# PRELIMINARY PLAN MEADOW LAKE INDUSTRIAL FILING NO. 1

A PART OF THE EAST HALF OF SECTION 9, TOWNSHIP 13 SOUTH, RANGE 64 WEST OF THE SIXTH PRINCIPAL MERIDIAN, COUNTY OF EL PASO, STATE OF COLORADO

# V1\_Preliminary Plan Drawings.pdf Markup Summary 10-24-2023

SHEET  
 SP  
 01

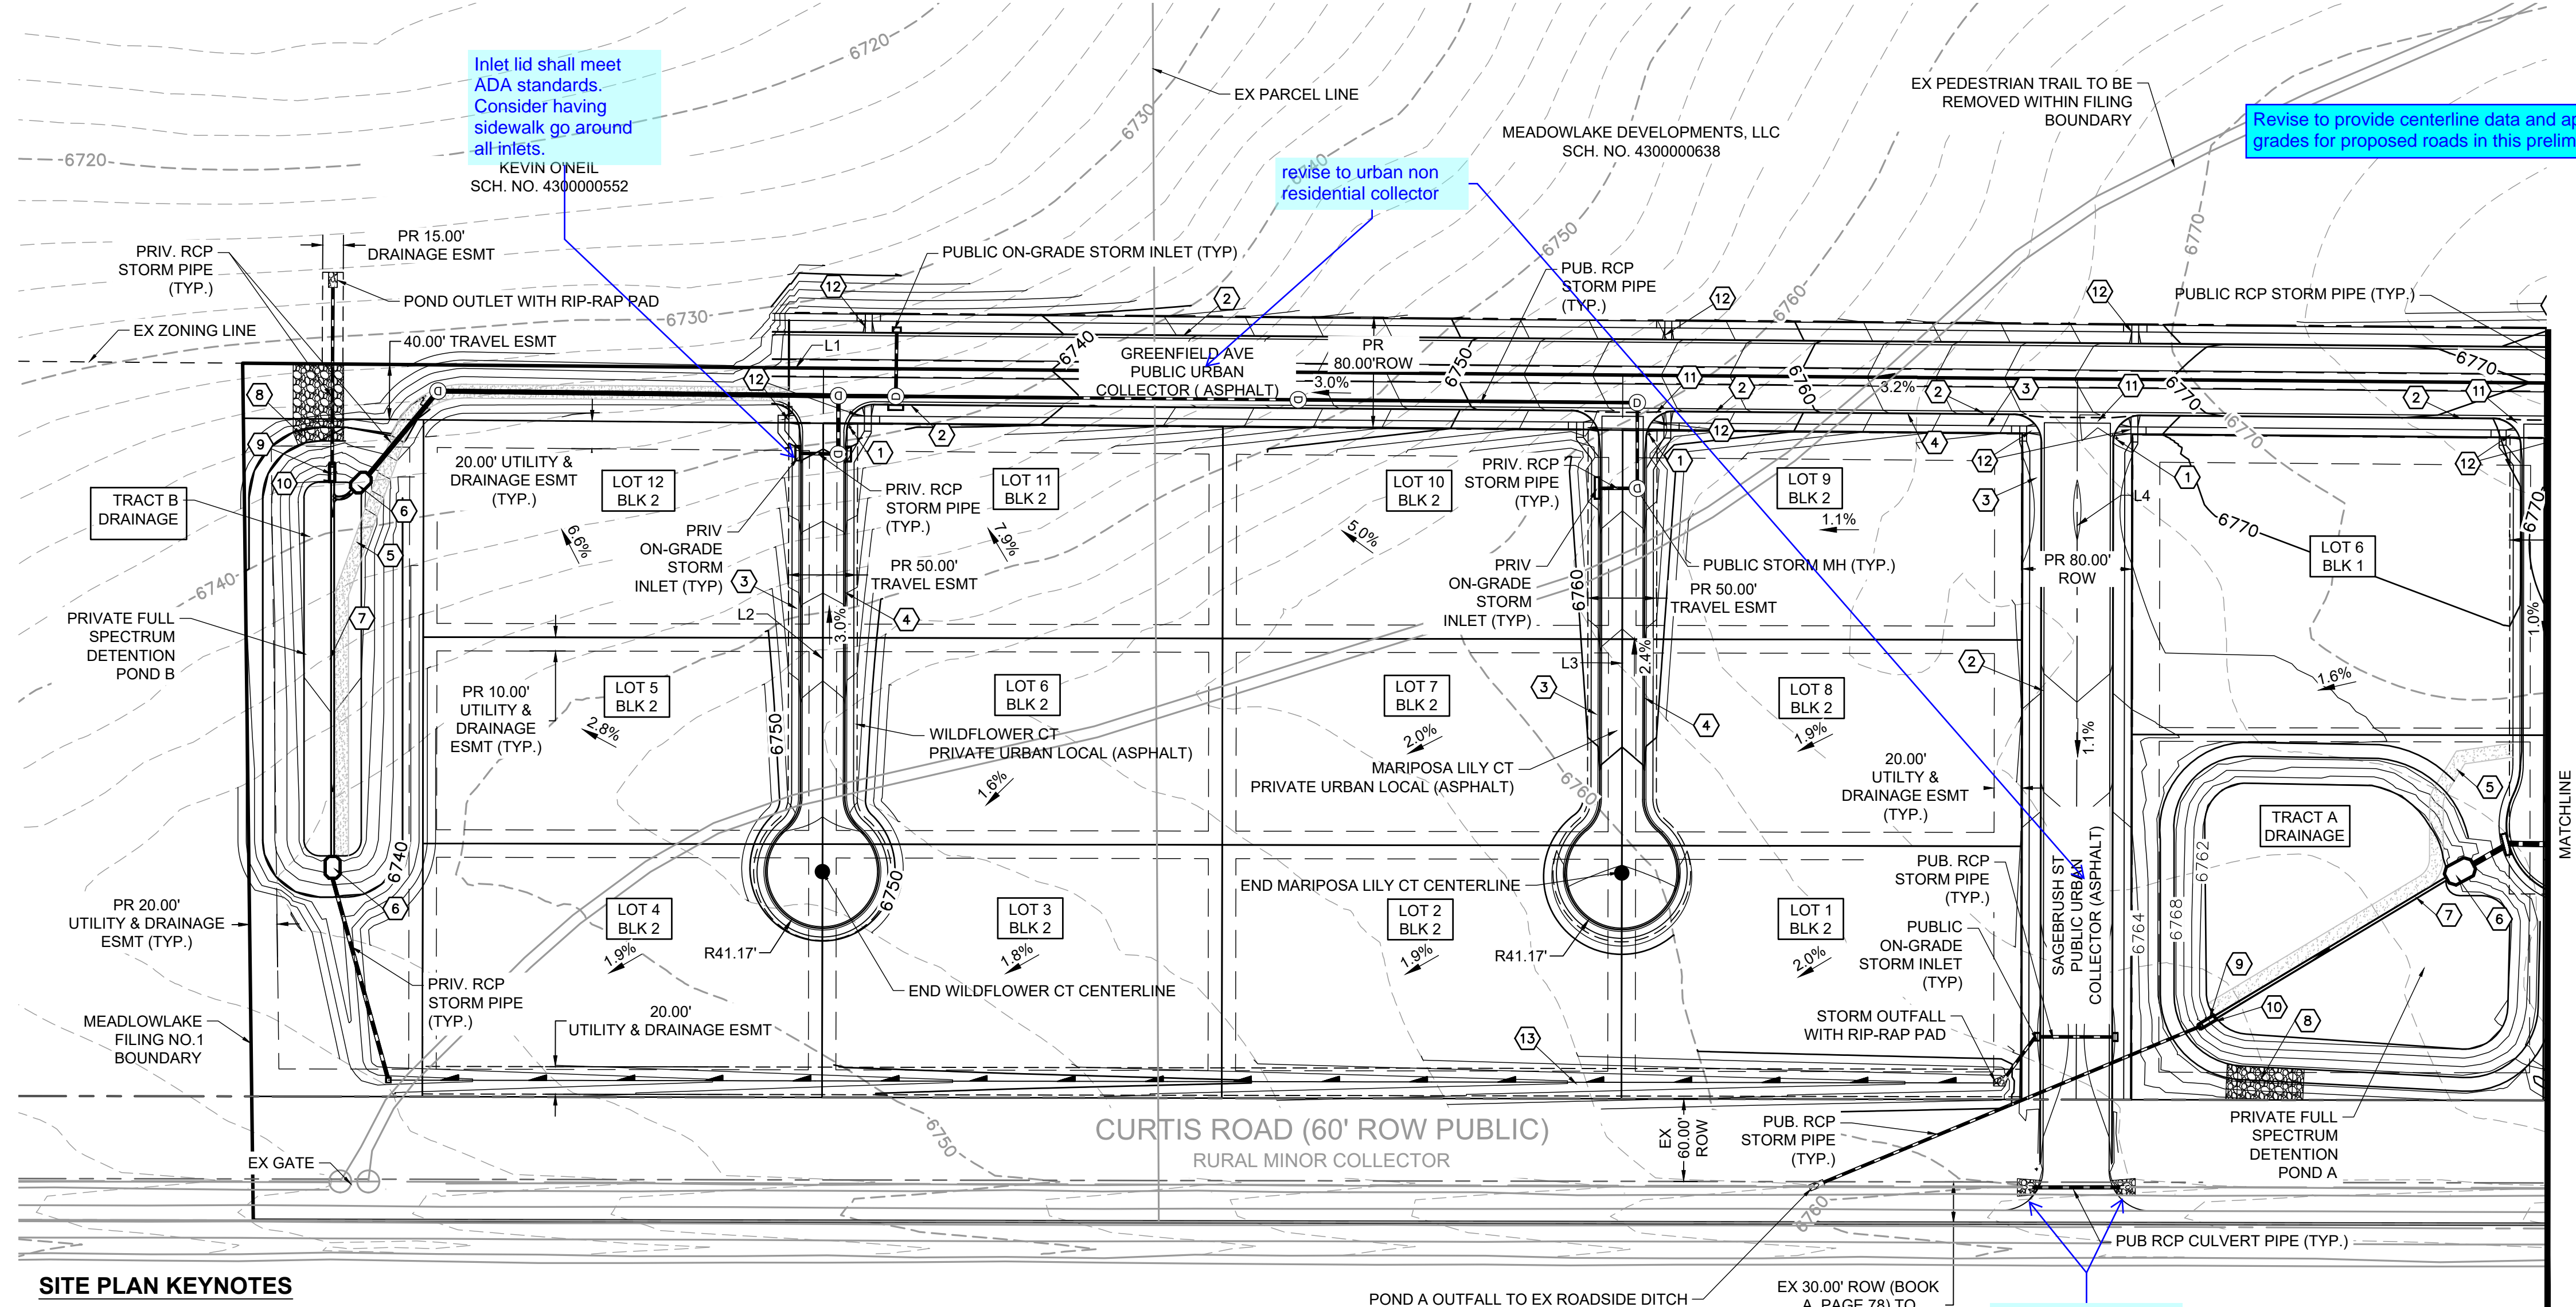
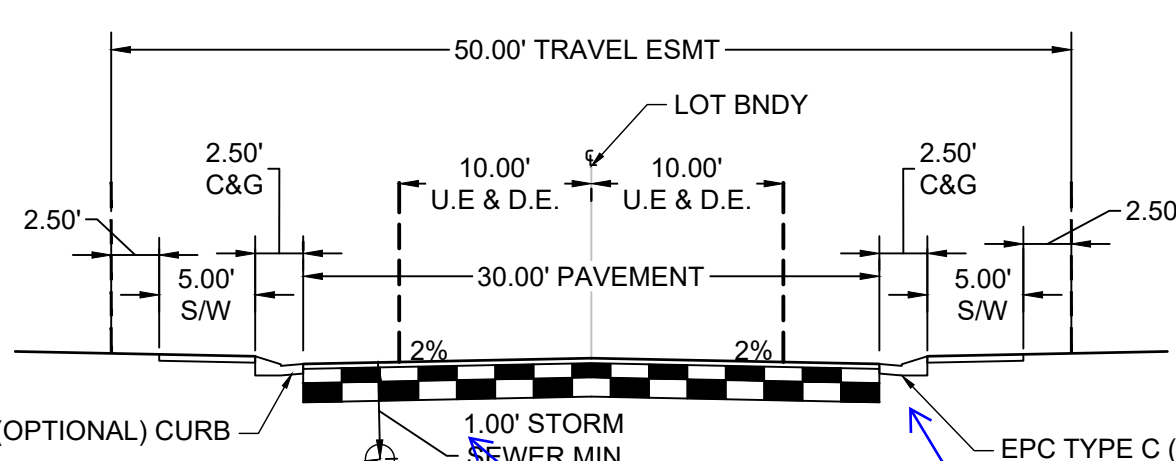
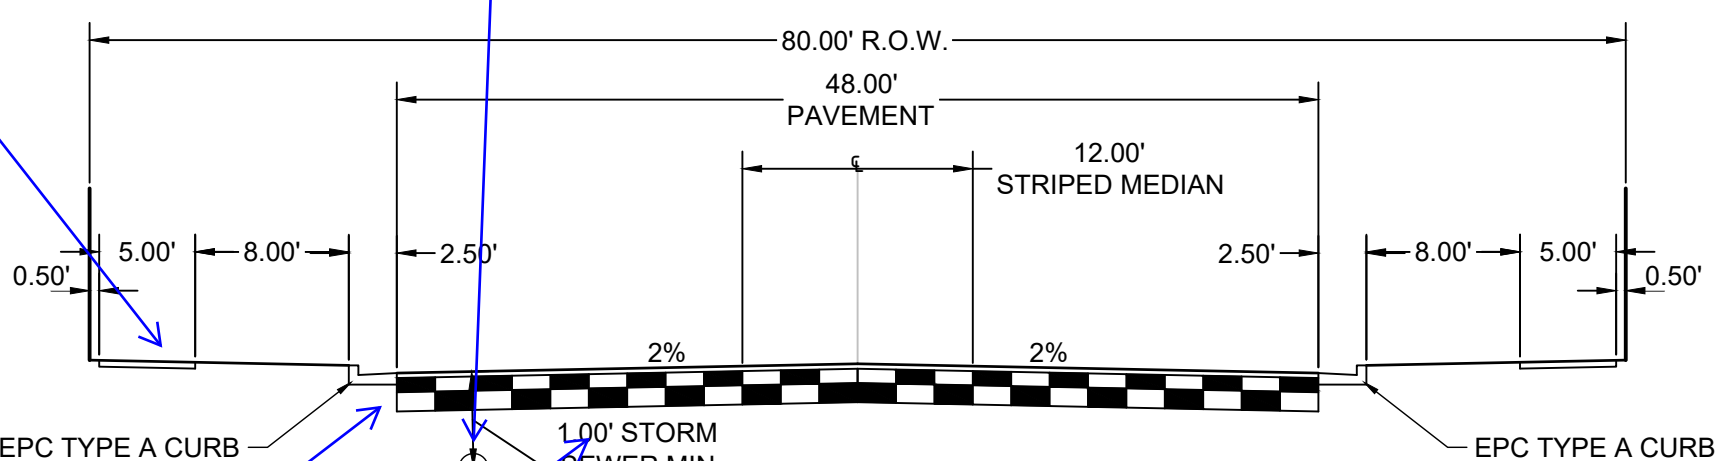
Depict the proposed fire hydrant locations.

Revise to include product/method that will be used to line the swale.

Update to show basecourse under curb.

Storm sewers shall be a min. of 2ft from road surface per ECM 4.3.6.A.3. revise

provide radii. refer to ECM 2-31 & 2-32

provide distance of storm sewer from centerline of roadway. Ensure that it meets standard county detail SD\_4-3

Label sidewalks.

Inlet lid shall meet ADA standards. Consider having sidewalk go around all inlets.

revise to urban non residential collector

Revise to provide centerline data and approximate grades for proposed roads in this preliminary plan.
